POWER GRID COMPANY OF BANGLADESH LIMITED (PGCB)

**DESIGN, SUPPLY, ERECTION, TESTING AND COMMISSIONING OF ASHUGANJ-BHULTA 400KV
TRANSMISSION LINE AND BHULTA 400/230KV SUBSTATIONS ON TURNKEY BASIS**

CLARIFICATION NO. 2

ADDENDUM NO. 2

Scale	N.T.S
Substitute for	
Designated	
Checked	
Approved	
Modification	
Page No	
Page No	
Drawing No	TL-013 (R2)

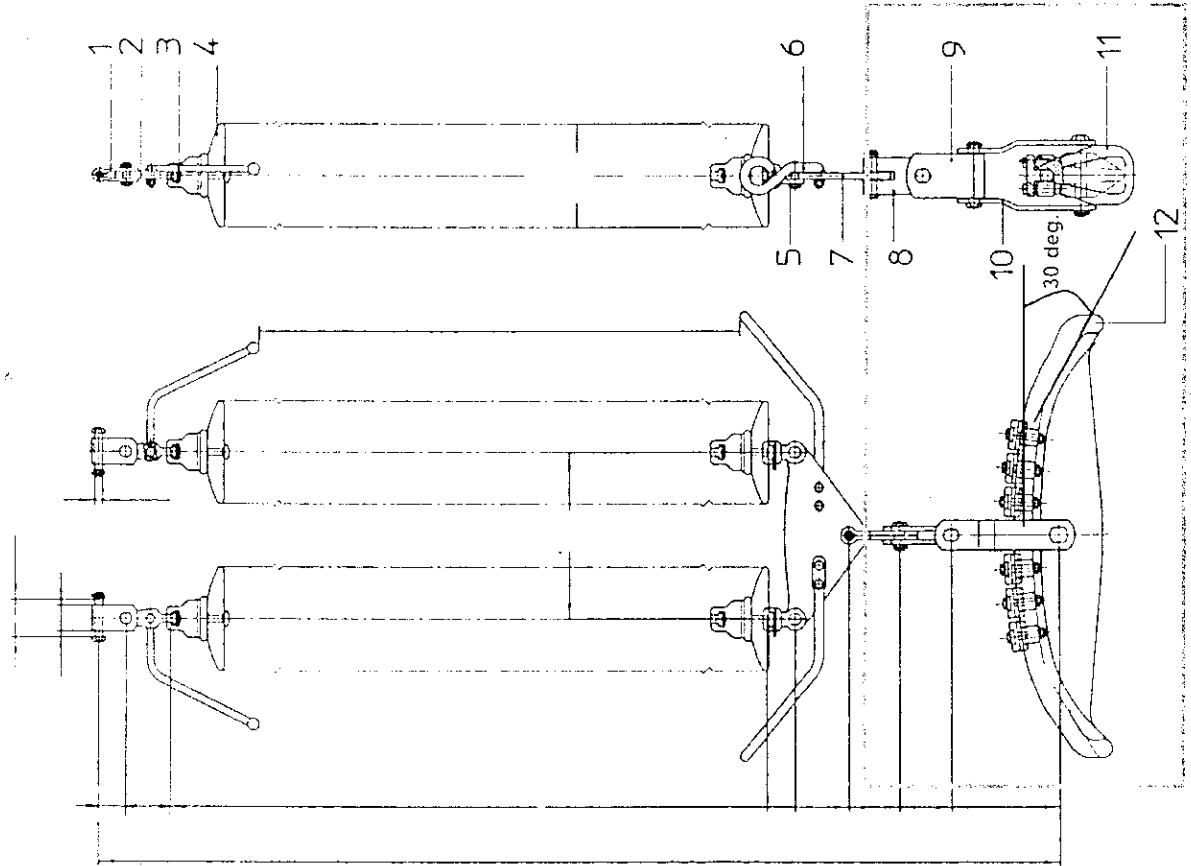
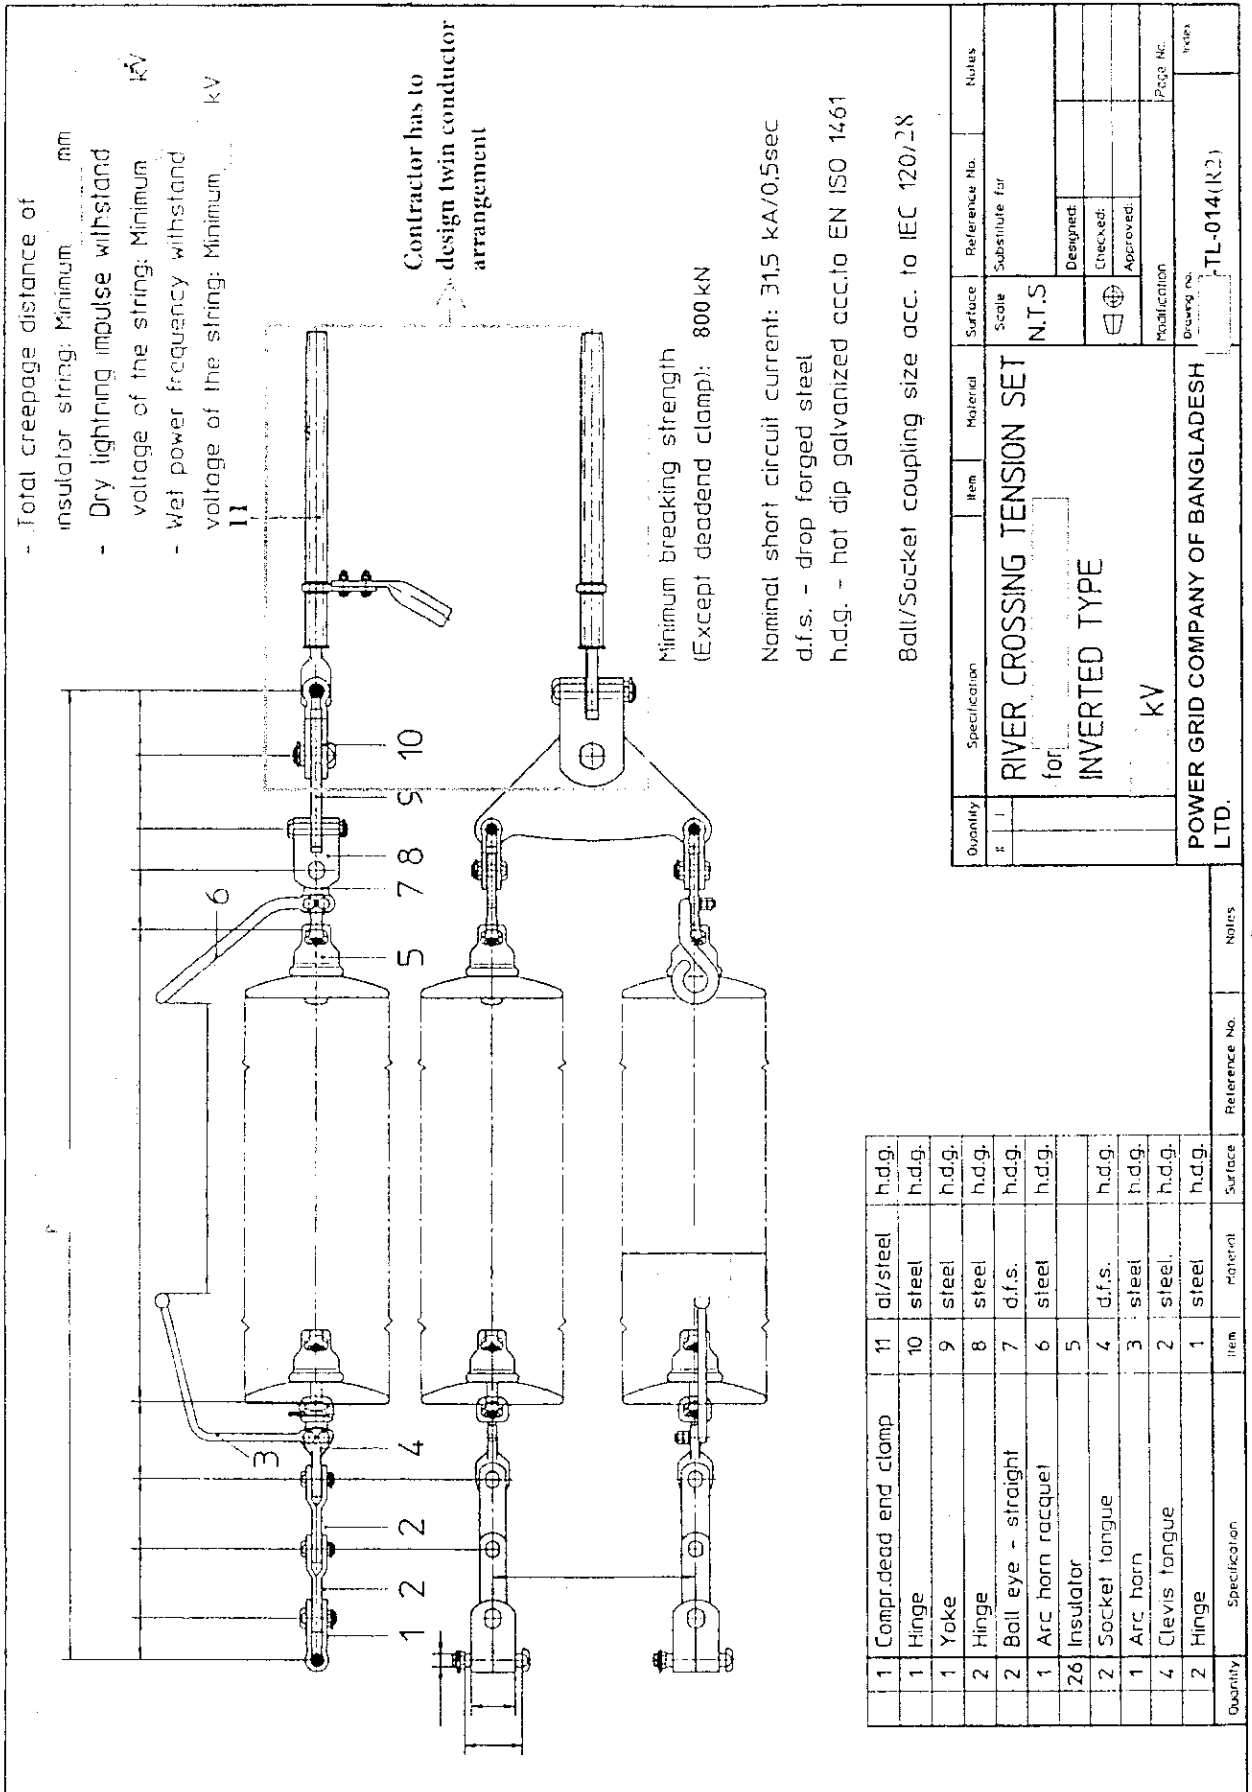
3. Drawing nos. TL-013 (R1) & TL-014 (R1) of Addendum-1 are replaced by enclosed revised drawing no. TL-013 (R2) & TL-014 (R2) respectively. [Enclosure-2]

Contractor has to design twin conductor arrangement

Answer 7: River crossing suspension set & tension set shall be of twin type. Contractor has to design the suspension set & tension set considering twin conductor arrangement. Please refer to addendum-2 in this regard.
